SEWAGE DISPOSAL TESTING

HOWARD COUNTY HEALTH DEPARTMENT
ENVIRONMENTAL HEALTH SERVICES

PROPERTY LOCATION: Lisbon Farms LOT NO. 11

MAP OF PROPERTY OF HOWARD ASSOCIATES

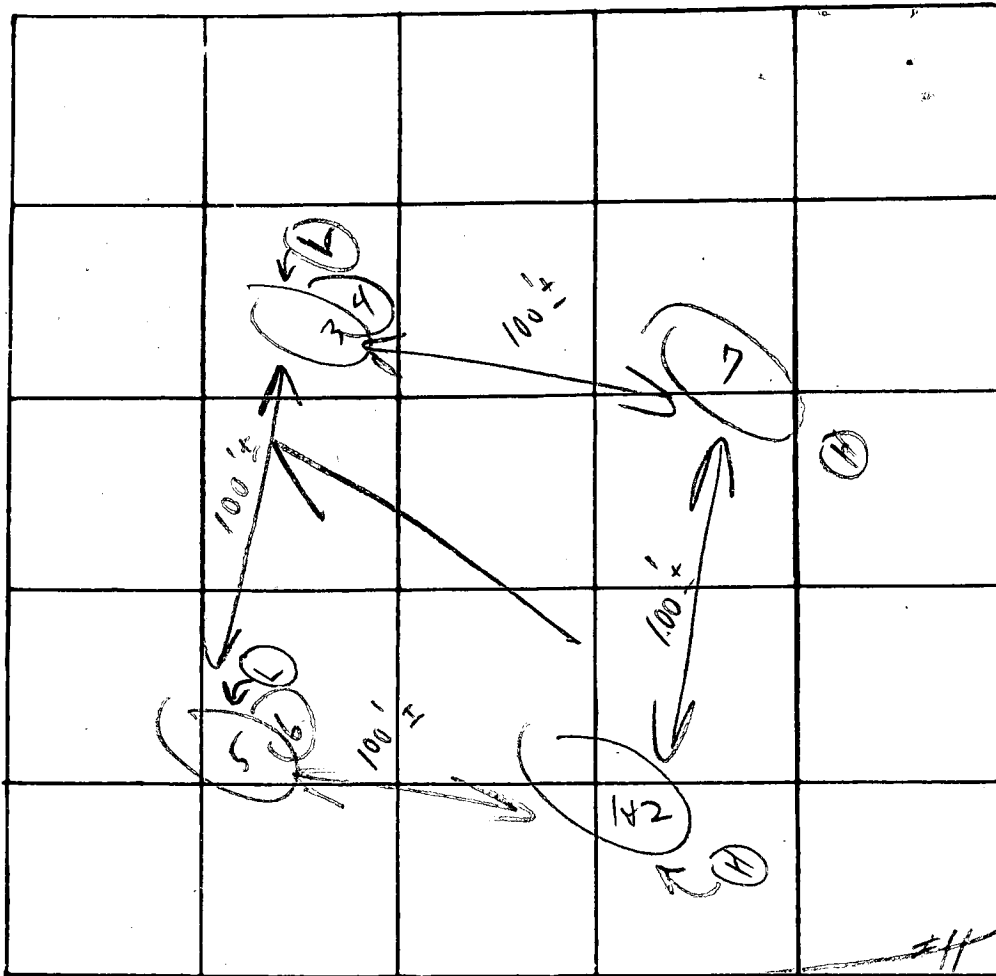
dry well to have 130 sq ft. effective
absorbent sidewall area per bedroom below
inlet. Inlet to be 2' below original grade and
maximum depth 11'. Location per plat 108'
in from front property line (being R/W) and
100' down from first point of turn in R/W,
being front property line, when coming down
R/W from lot #12. (Perc hole (1+2))

REASONS FOR REJECTION OR HOLDING 6/22/77 for retested holes
C.B.S.

APPROVED BY C.B. Streaker FOR Dry well 4/100 DATE 7/18/78
P.D. well + trench
(KIND OF SYSTEM)

Plot 11: Plan for resident Bldg Permit
Wood Deck with Fence for 15' above swimming Pool

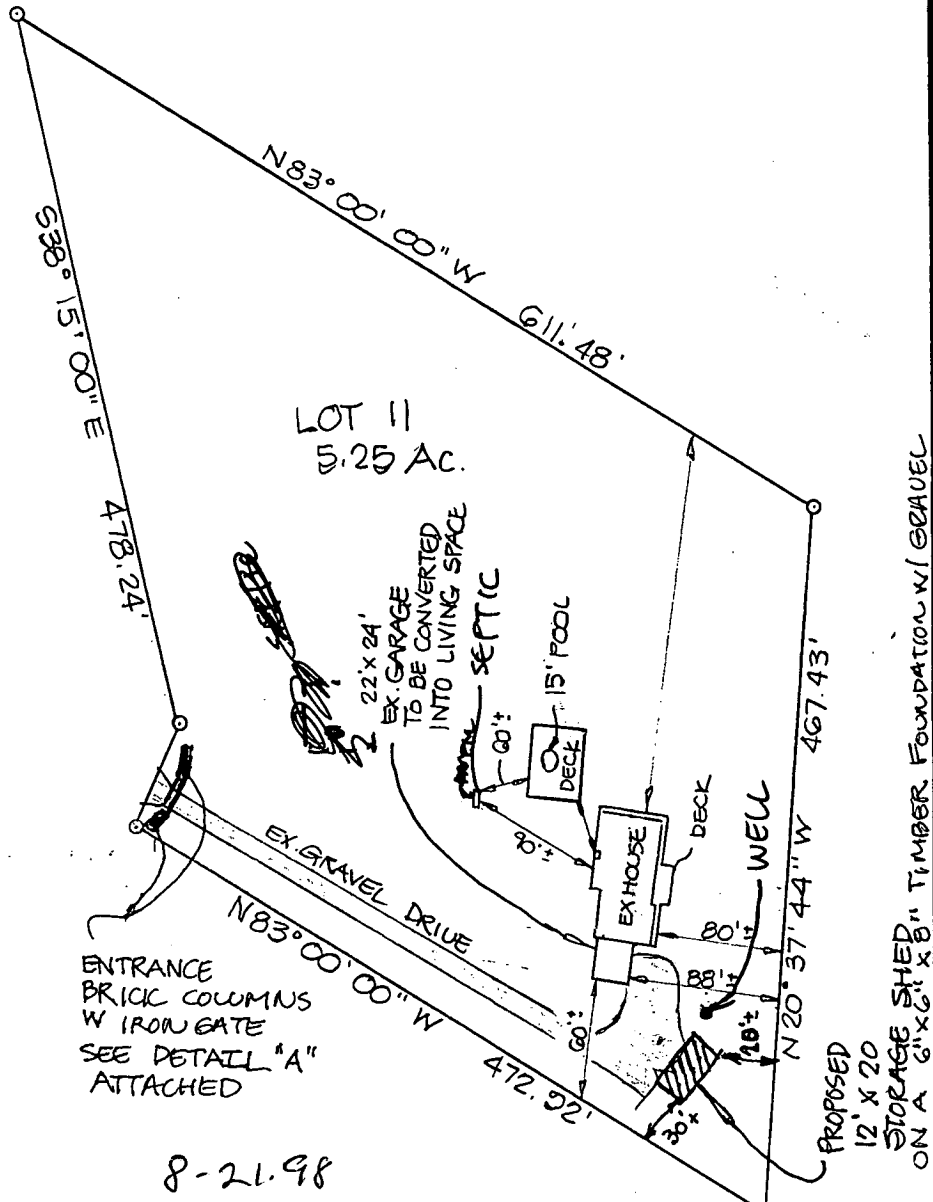
Septic tank inside horse ring.

5/12/93
OK TO SIGN
BP 48432
R.H.

MR. MORRIS & NELIDA MEILLER 16420 OLD FREDERICK RD. MT. AIRY, MD. 21771 410-442-1881		
PROPOSED 12' X 20' STORAGE AMEND SUBORDINATE PERMIT EXCISE LOT		
LOT 11 5.25 Ac.		
DATE 7/98	SCALE: NONE	JFM

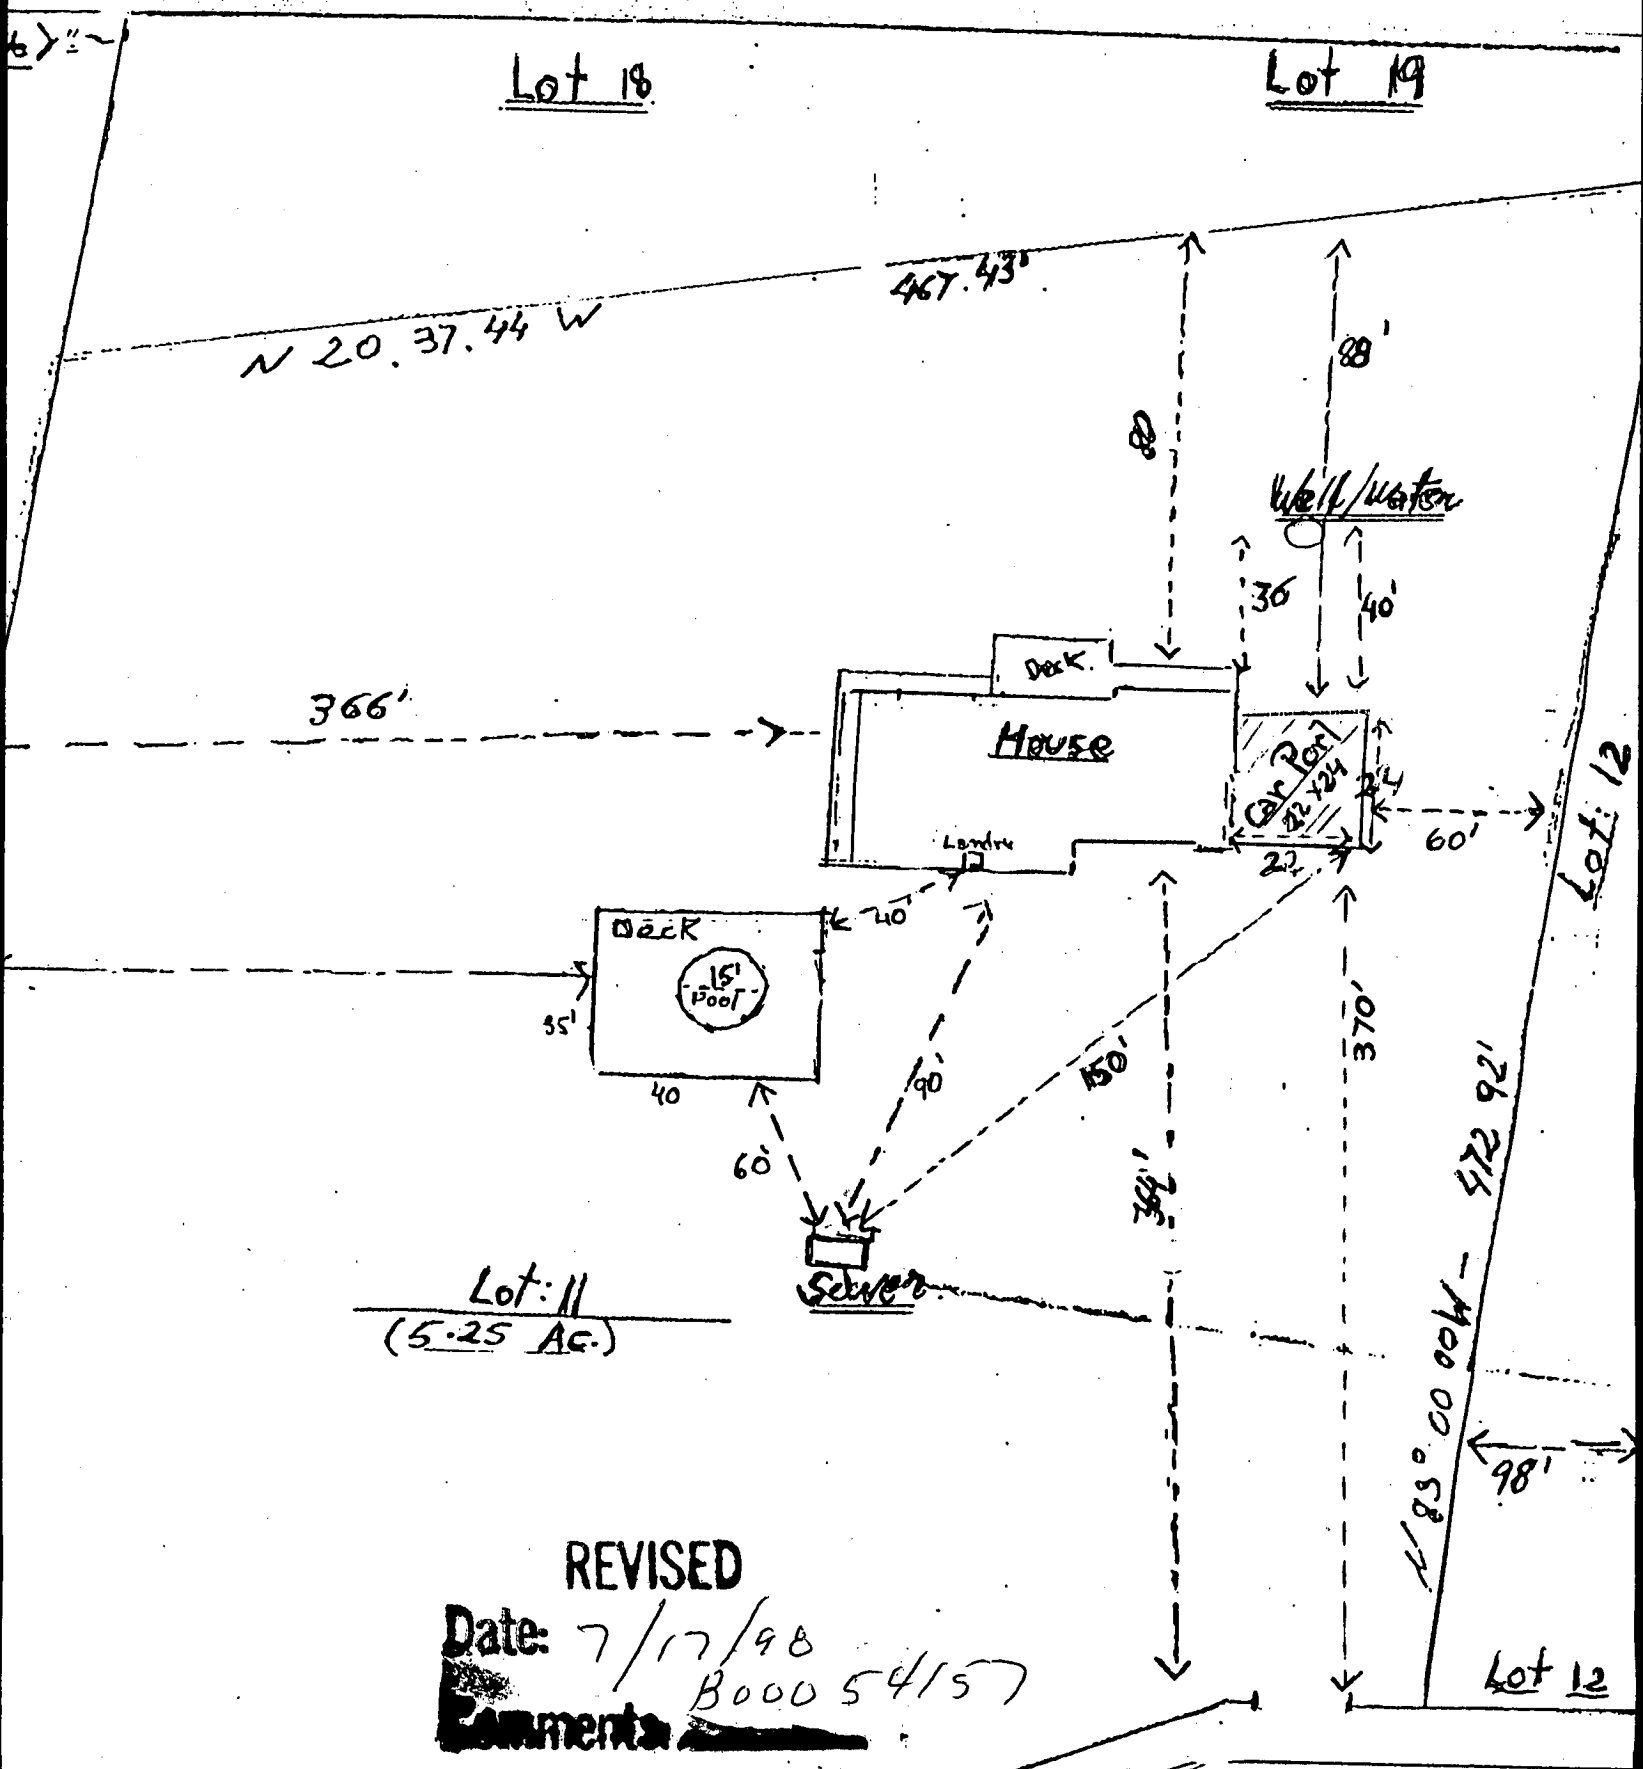
BPT - WELL NOT LOCATED
RELEASE PERMIT W/NOTE TO OWNER
TO MAINTAIN 30' FROM WELL W/ STRUCTURE.
JP

Please find enclosed (4) four copies of the requested Plot Plan to amend building Permit No. B00054157. The garage is being changed into a two-bedroom and family room area. If you should have any question or concerns please feel free to contact me at (410) 442-1881.

PER BP OFFICE
APPROVED 7/28/98
W/O H.D. COMMENT
